# Access Compliance Report

### (Curb Ramps)

Intersection ID: 2625	Main Street: KILMARTIN_LN	Cross Street: TULLAMORE_LN	Location: NE
ADA ID: 887B2879E86C	Ramp Type: Perp	Initial Pass/Fail: Fail	Overall Compliance: No
		Severity Score: 25

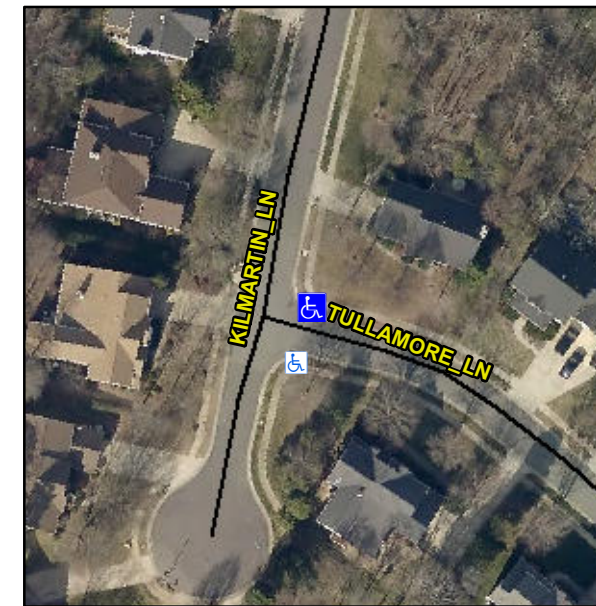
**Not Found, R304.2.2**

Compliance	Description	Data	Compliance	Description	Data
N/A	Ramp Length (in)	46.0	No	Ramp Slope (%)	14.2
Yes	Ramp Width (in)	54.0	Yes	Ramp XSlope (%)	0.5
N/A	Flare Type LT	N/A	N/A	Flare Type RT	N/A
N/A	Flare Slope LT (%)	N/A	N/A	Flare Slope RT (%)	N/A
N/A	Flare Traversable LT?	N/A	N/A	Flare Traversable RT?	N/A
N/A	Landing Length (in)	N/A	N/A	DWS Provided?	N/A
N/A	Landing Width (in)	N/A	N/A	DWS Contrast?	N/A
N/A	Landing Slope (%)	N/A	N/A	DWS Length (in)	N/A
N/A	Landing X Slope (%)	N/A	N/A	DWS Full Width?	N/A
N/A	Landing Curb? (Y/N)	N/A	N/A	DWS Offset (in)	N/A
N/A	Shared Landing?	N/A			
N/A	Gutter Ponding?	N/A	N/A	Gutter Slope (%)	N/A
N/A	Gutter Lip Ht (in)	N/A	N/A	Gutter X Slope (%)	N/A
N/A	Painted X Walk1?	No	N/A	Painted X Walk2?	N/A
	X Walk 1 Direction	To S		X Walk 2 Direction	N/A
N/A	X Walk 1 Width (in)	N/A	N/A	X Walk 2 Width (in)	N/A
	X Walk 1 Slope (%)	0.6		X Walk 2 Slope (%)	N/A
	X Walk 1 X Slope (%)	1.5		X Walk 2 X Slope (%)	N/A

**Remove & Replace Entire Ramp.**
